Appendix A Design Update 01, February 2025

Design Update Request/Notification

FORM A – SUMMARY OF REQUEST/NOTIFICATION			
Project:	The Medworth Energy from Waste Combined Heat and Power Facility Order 2024 Made: 20 February 2024		
Reference:	CP3_R2_DU01		
Originator:	Medworth CHP Limited (the Developer)		
Name:	Tim Marks	Position:	Head of Planning
Issued to:	Cambridgeshire County Council	Date issued:	05/12/2024

EfW CHP Facility Design Update 01

Figure 3.7iii
EfW CHP Facility Elevations

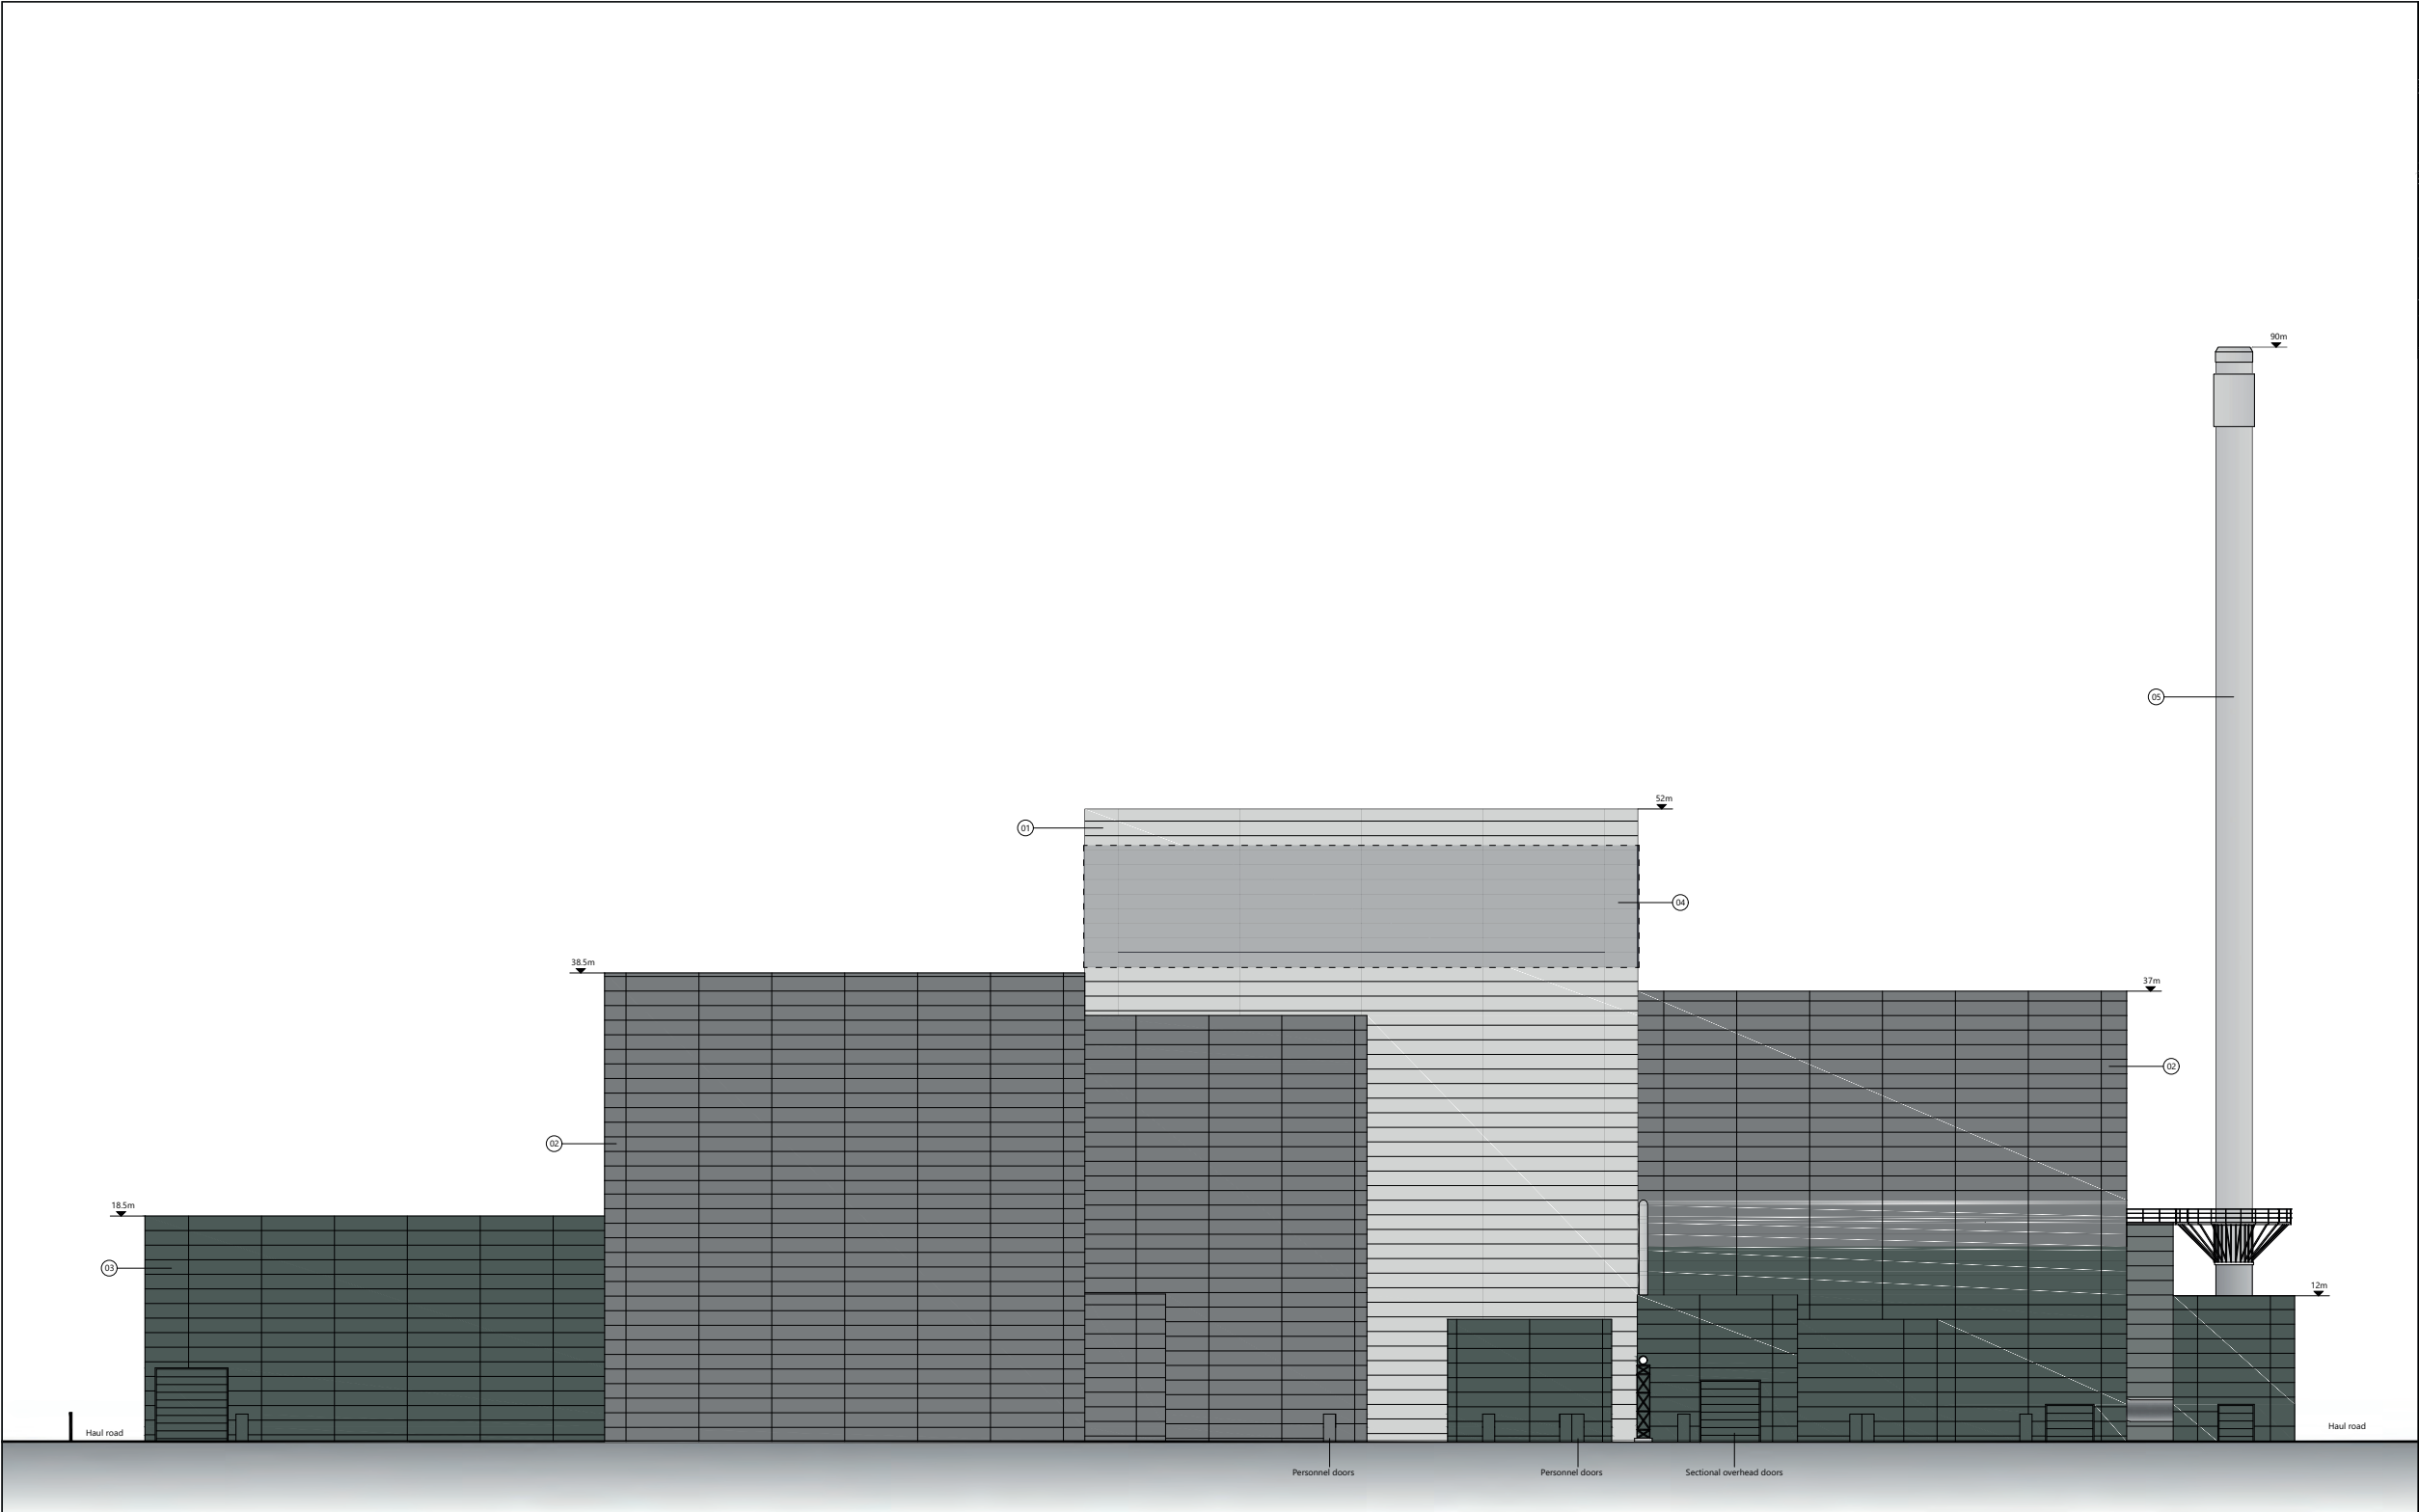
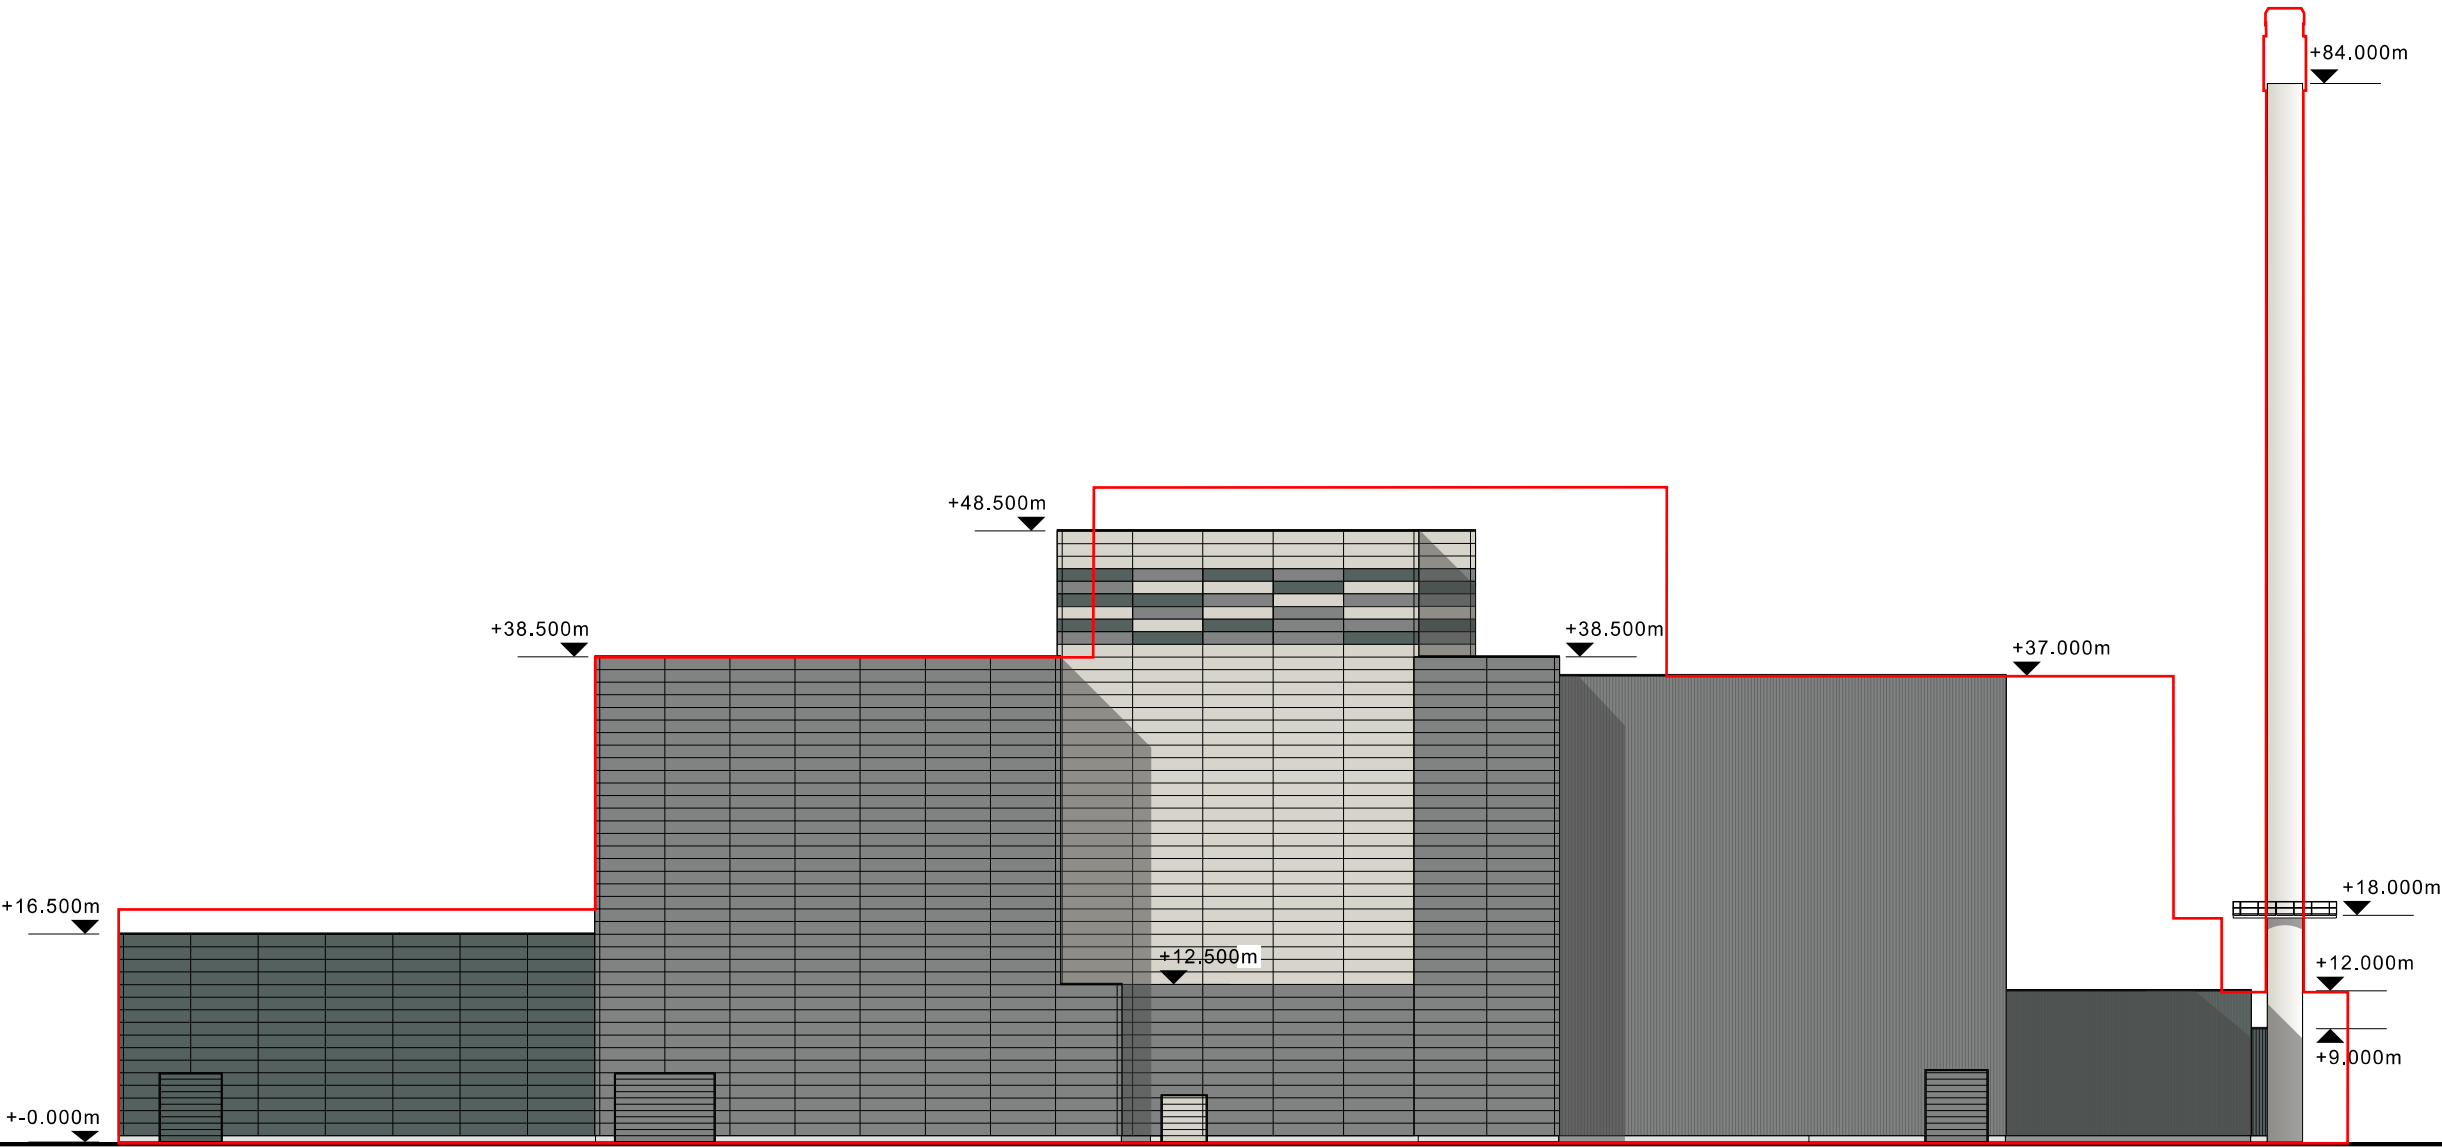
Outline taken from 3.7_i-iv-3.8-EfW-CHP-FacilityElevations (West Elevation)
